100 Mbit/s 802.5 PHY Layer – Changes to Standard

T. J. Ross
IBM, NHD, D63/656
RTP, NC

September 29, 1997

Figure X.XX:

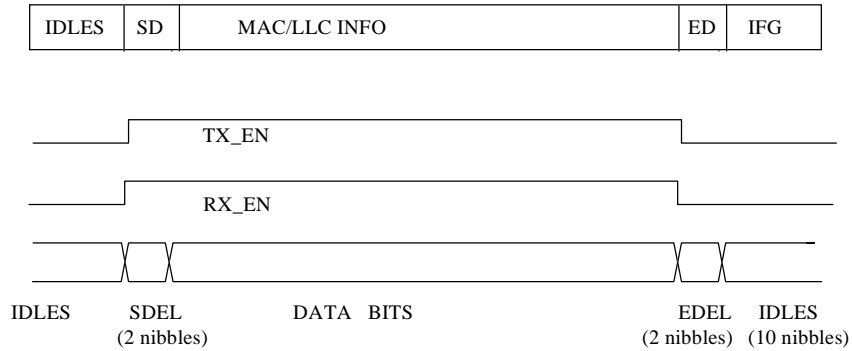
[Note for Tam: please check the exact requirements for RX_DV per 802.3 Figure 22-6. Must RX_DV rise immediately after SSD? Clause 22 does not require, but clause 24 (TX) state diagram definitely does!]

Alignment between the Frame boundaries and the MII control signals.

Framing

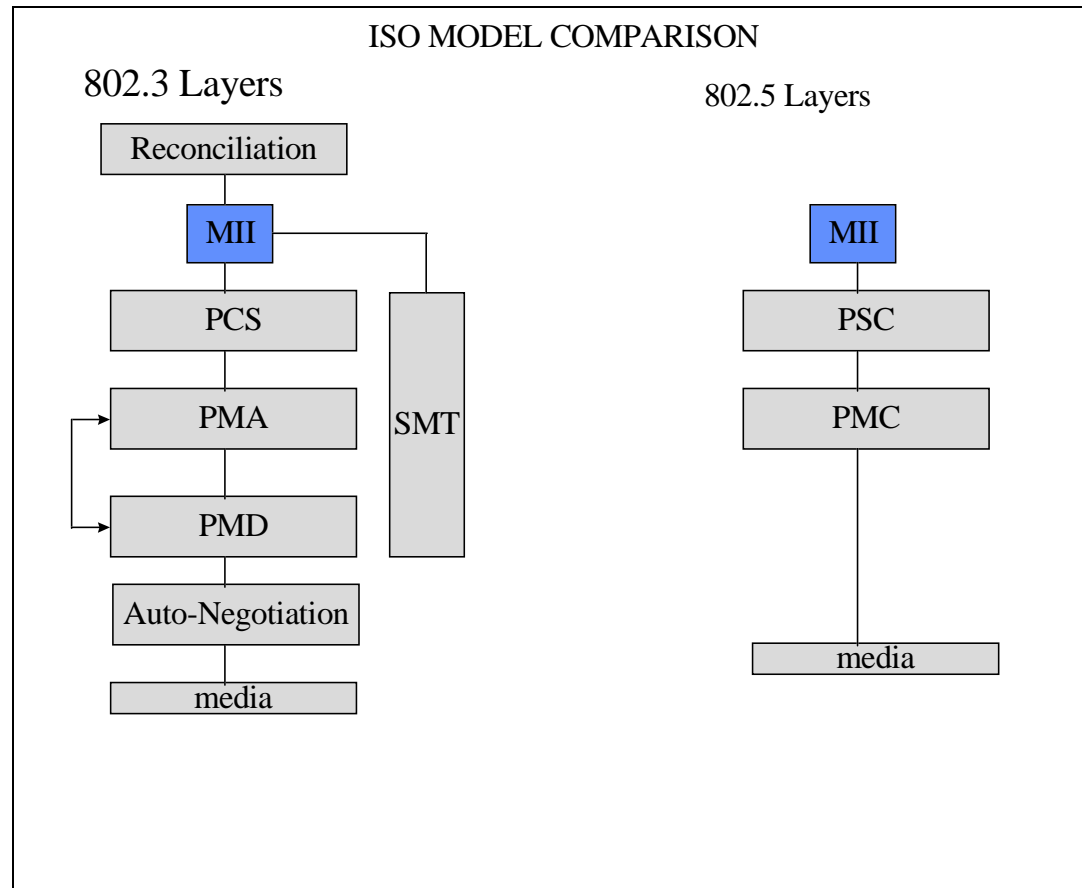
(someplace, the IFG needs to be defined as at least 10 nibbles of Idles)
